**R92 – 2024**

### **Certificate of Appropriateness for work in the Historic Districts:**

**Historical Architectural Review Board  
COA Preliminary Review Sheet**

**HDC-2024-00029**

**Current Roof (Applicant)**

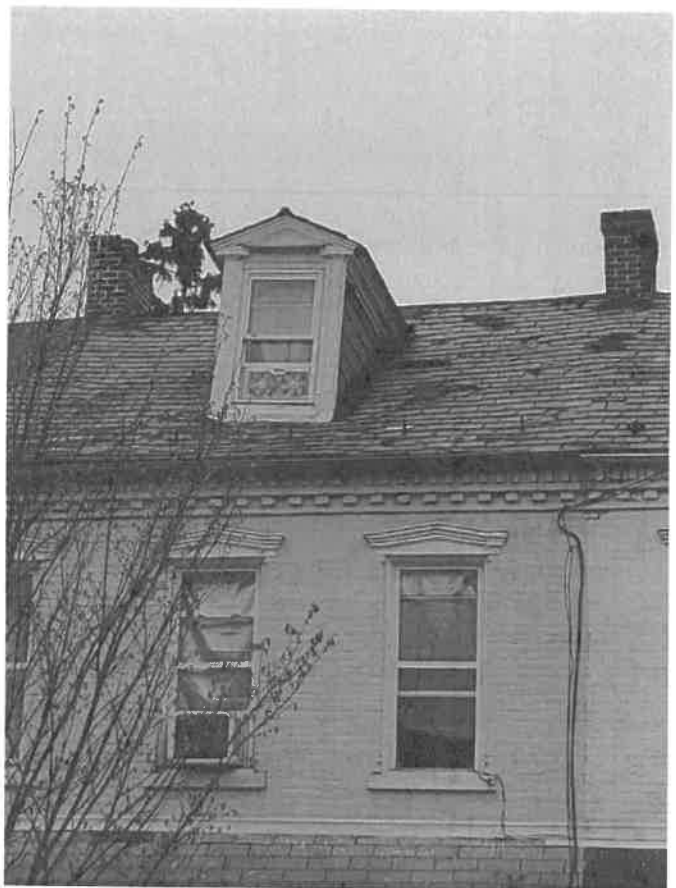
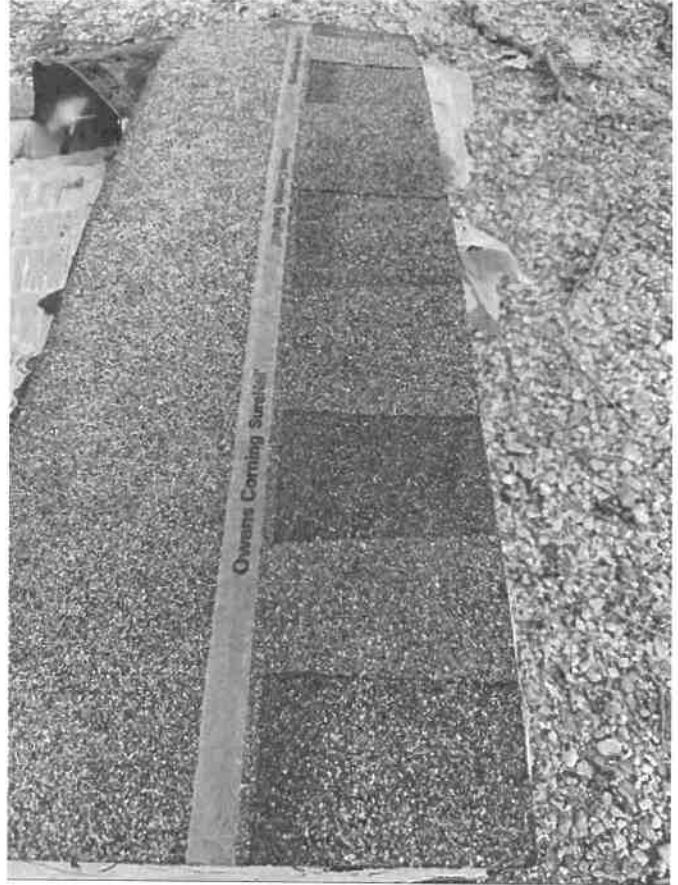
**Observations & Comments:** The current roofing materials appears to be original slate. The adjacent property to the left has replaced their slate with a 3-tab shingle and the property to the right still retains the original slate. The proposed replacement materials is an architectural shingle that has an exaggerated taper and overlap, which is not historically appropriate. A more appropriate replacement, if not replacing in-kind, would be a replacement material to resemble the original slate as closely as possible. An example of this is the GAF Slateline Shingle or similar.

**Discussion:** A question was posed to ask if the application includes the dormer. The applicant noted that they would be amenable to using a 3-Tab estate grey shingle instead of an architectural shingle and provided a photograph of the proposed product. It was noted that the 3-Tab shingle does not replicate the slate roofing as appropriately as a product similar to the GAF Slateline. Since the upper roof is a slate material, the 3-Tab is not appropriate and would need to be replaced with slate or a replacement that resembles slate. The color should also match the existing.

- Replacement material to resemble the original as closely as possible (GAF Slateline Shingle or similar would be historically appropriate.)

- Replacement material to resemble the original roofing as closely as possible (GAF Slateline Shingle or similar) will be utilized.

**Current Roof (Applicant)**

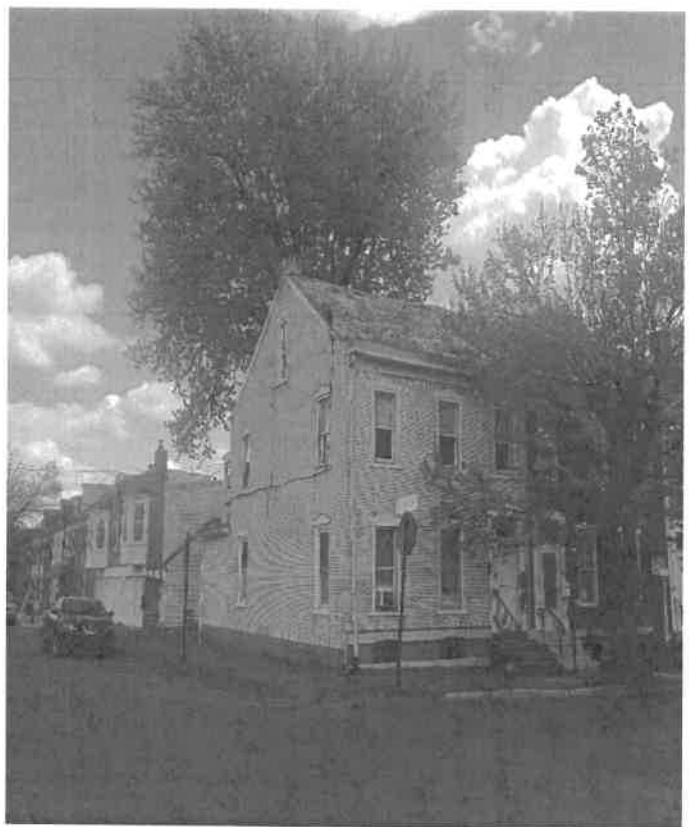
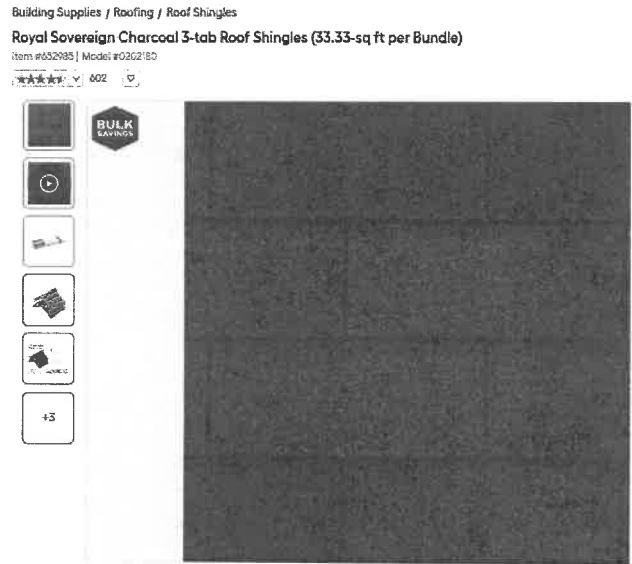
**Observations & Comments:** It appears that the existing roof is a non-historic 3-tab asphalt shingle roof and the proposed replacement material is an in kind replacement. Though, it is not clear if the proposed color matches the color of the existing roofing. The guidelines indicate that replacement materials should match the existing in color, which appears to be a medium to dark grey.

**Discussion:** The applicant noted the shingle colors will match the existing and the previous owner did a lot of repairs; the front is slate with silver coat and the back is 3-tab with architectural shingles. Given the clarification of the current roofing material, GAF Slateline or similar is recommended for the front slope. Discussion was held about what should be considered in-kind given the number of roofing surfaces that exist on the roof. The applicant noted that it is an increased expense for the shingle cost as well as installation cost for the GAF Slateline shingles. The applicant noted the Slateline shingles install differently than architectural shingles and there is less to a bundle for Slateline. Given the existing conditions, it was noted that GAF Slateline or similar would be acceptable at the front and 3-Tab or Slateline will be acceptable at the back.

- Replacement material to resemble the original roofing as closely as possible (GAF Slateline Shingle or similar) will be utilized.
- At the back slopes, if the owner chooses, in-kind replacement of 3-Tab shingles can be utilized in lieu of Slateline.
- Color to match existing roofing materials (Charcoal or similar.)

**Current Roof (Applicant)**

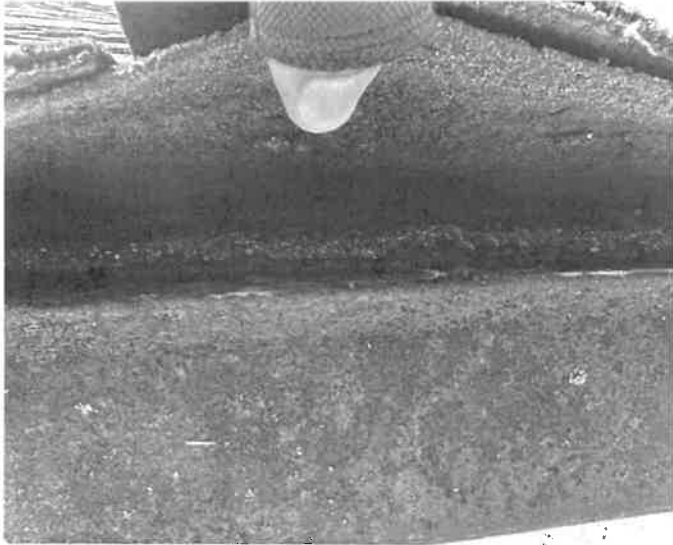
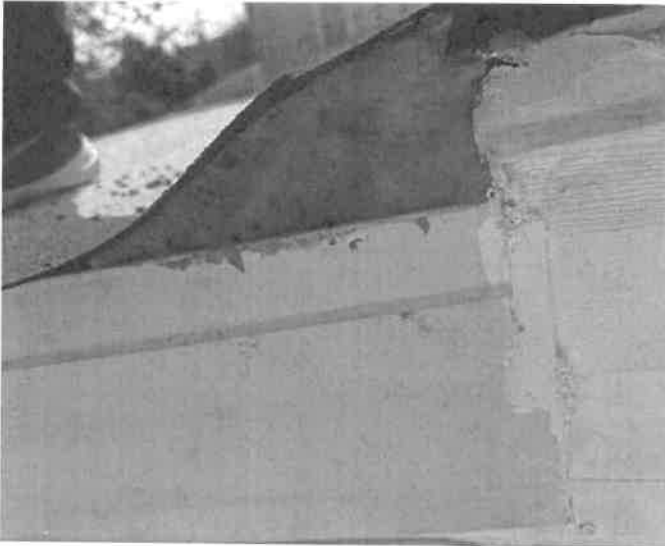
**Observations & Comments:** The current architectural shingles on the roof are not historic and the proposed Timberline HDZ architectural shingles are an in-kind replacement.

**Discussion:** The applicant noted that the owner's insurance will be canceled May 15<sup>th</sup>, and the roof is currently leaking. Mr. Sadiua noted that normally the process to approve the COA is approximately 1.5 months, but Mr. Franzone noted that if approved, the emergency repairs could commence. The applicant noted there are currently 2 layers of roofing and the siding on the dormer that is coming loose will be repaired in kind. The applicant noted the color the owner requested for the replacement was GAF Weatherwood rather than Pewter Grey; Jessica noted the color should match the existing per the design guidelines. Mr. Huber noted concern about approving an architectural shingle, but it was noted that it would be acceptable to either install a 3-Tab or Slateline shingle in a dark grey color. The Applicant noted the warranty for the proposed architectural shingle was 50 years, but the 3-Tab shingle is a 25–30-year warranty.

- A 3-Tab shingle or a GAF Slateline or similar shingle to match the existing color is utilized for the replacement.

**Bay Window Roof (Applicant)**

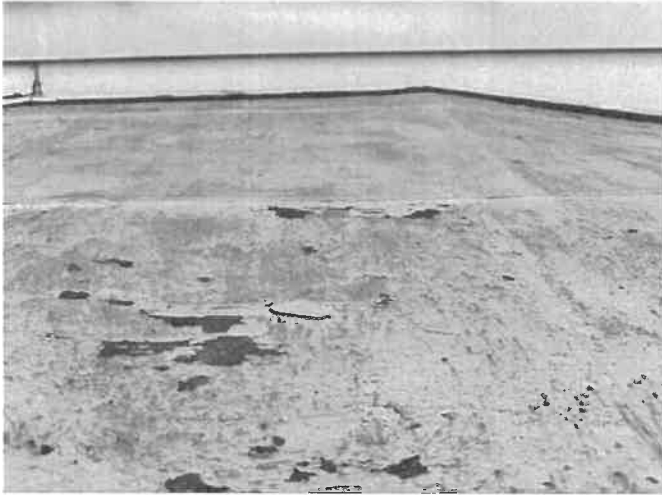
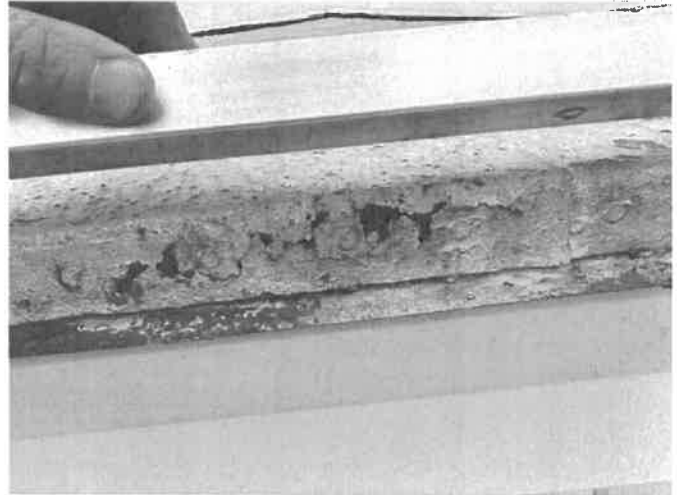
**Observations & Comments:** The current roofing material on the porch roof is a 3-tab shingle; the current roofing material on the bay window is a flat seam metal that has been coated. Although the applicant references an adjacent property where EPDM roofing was utilized, this is not appropriate per the design guidelines. Both roofs can be seen from the public right of way; the bay window roof less so than the porch roof. An appropriate replacement would be to either replace the porch roof in-kind with 3-tab shingles or replace with an historically appropriate flat seam metal roof. For the bay window roof, it would be appropriate to repair and recoat the flat seam metal or replace in-kind. The metal edging material is appropriate; the color selection is not in the purview of the HARB.
